## **Supplemental Information Requested by County**

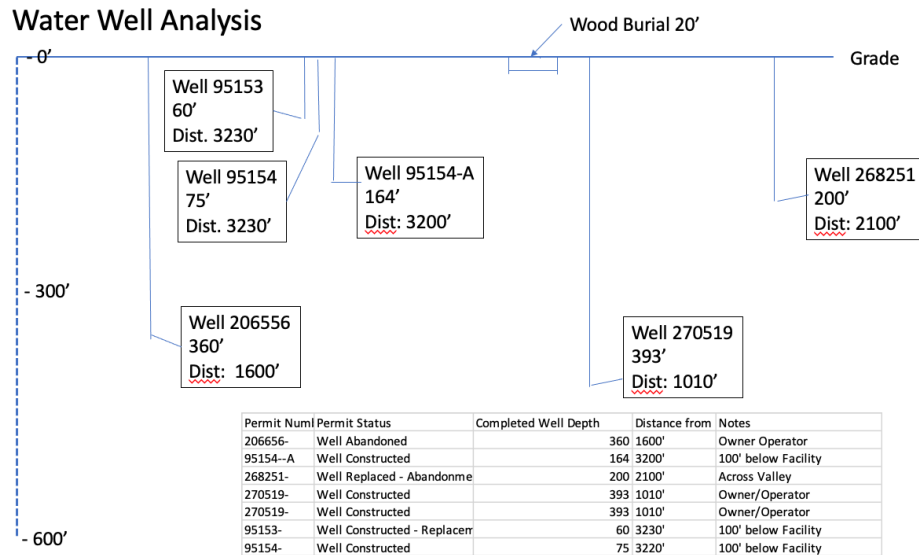
### **2. Monumenting - Describe in Greater detail how the facility will be Monumented**

The final, post-closure design for the Facility does not anticipate Fencing so as to return the land to its original use of grazing. However, we will post signs at the corners of the facility stating that it is a Wood Preservation Site and subject to limited uses as prescribed by the State. We will likely include an Internet link or QR Code that can be used to find greater details.

In addition, each of the Phases' pits will be monumented using Brass Markers in a single corner, likely NE, which will be geolocated, used as the original reference point for each pit whose size and location will be documented in the final as-built plot to be filed with the County as per the following:

Run-off Analysis – to nearest waterways

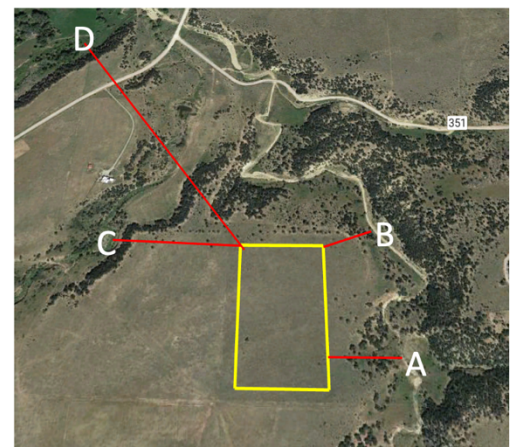
Per an earlier note: Brown stated that he would like to see a report on water table depth and whether this project has the potential to impact the water table downstream.

Below is a water-way analysis showing the proximity to the facility to each of the potential run-off sources. The facility is out of the 100 year flood plain positioned on a hill. Run-off paths are a substantial distance away which minimizes any potential for leachate reaching them. Again, wood is non-toxic. Methane production should be minimal and will be monitored regularly. If any risks are identified, mitigating actions will be taken.

A) Distance to Ritter Arroyo SE – 538'

B) Distance to Ritter Arroyo NE – 423'

C) Distance to Drury Spring & Arroyo – 984'

D) Distance to Cucharas River – 2630'

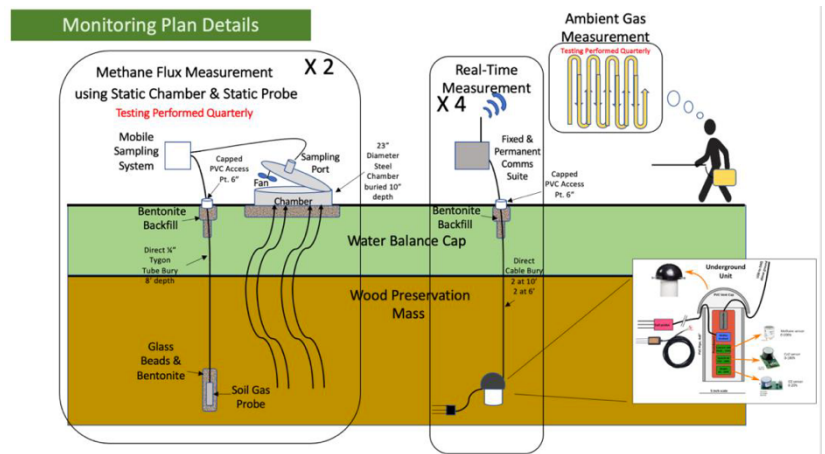
## 5. What is the contingency for groundwater contamination?

We take groundwater contamination potential very seriously. However, we see it as an extremely unlikely scenario for 3 reasons:

- 1) The materials we are burying are natural, non-toxic and non-hazardous.
- 2) Our Pit cover and topographic design (i.e water balance cap (per State recommendations), berms and drainage paths) are specifically intended to prevent water from entering the wood chamber. Success in the project is a dry storage area.
- 3) We will be performing real-time monitoring of moisture conditions in the pit and will take mitigative actions long before leachate conditions could be reached. The graphic to the right shows the extent of monitoring that will be performed for 30 years or more.
